STAFF RECOMMENDATION

323 South 15th Street

Application: New Construction—Addition and Outbuilding

District: Lockeland Springs-East End Neighborhood Conservation Zoning Overlay

Figure 4 (left) shows the new window plan for the left facade and Figure 5 (right) show the existing window openings.

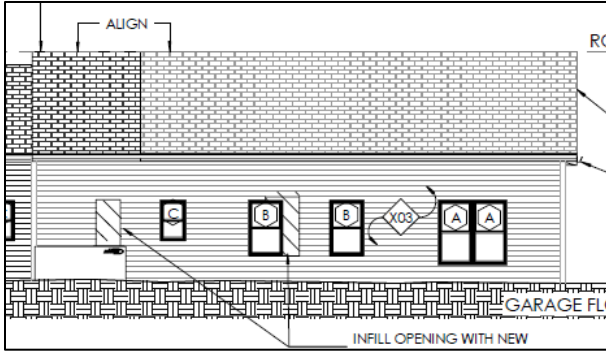
The applicant also intends to alter the window openings on the side facades. The existing left façade (Figure 5) has few window openings. The applicant intends to add double hung, vertically-oriented windows to this façade. Staff finds that the house likely had more window openings on this façade prior to the alteration of the siding, although no historic photographs of that façade have been found. Because the windows are similar in size and location to where windows on similar houses are located, staff finds that the addition and alteration of the window openings on the left façade to meet the design guidelines.

Figure 6 (left) shows the new window plan for the right facade and Figure 7 (right) show the existing window openings.

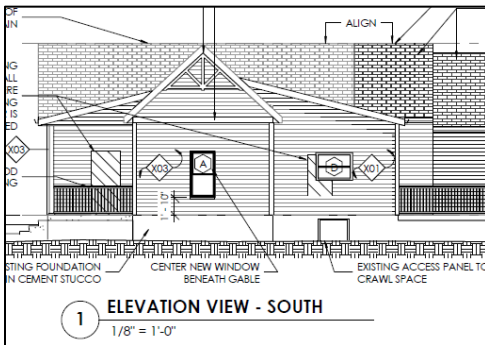
On the right façade, in addition to removing the door opening, the applicant intends to alter a window opening at the rear of the side façade. Because the window is in the back portion of the side façade, staff finds that this window alteration is appropriate demolition.

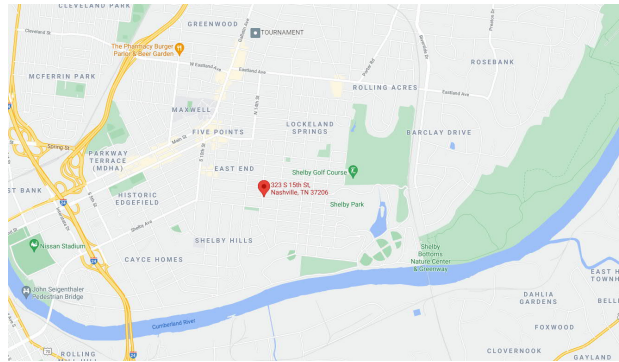
With staff’s approval of all windows and doors and the roof shingle color, staff finds that the known materials meet Section IV. of Part I and the Lockeland Springs-East End chapter of Part II. of the consolidated design guidelines for the turn-of-the-century neighborhood conservation zoning overlays.

Overall, staff finds that the design of the proposed garage meets the design guidelines.
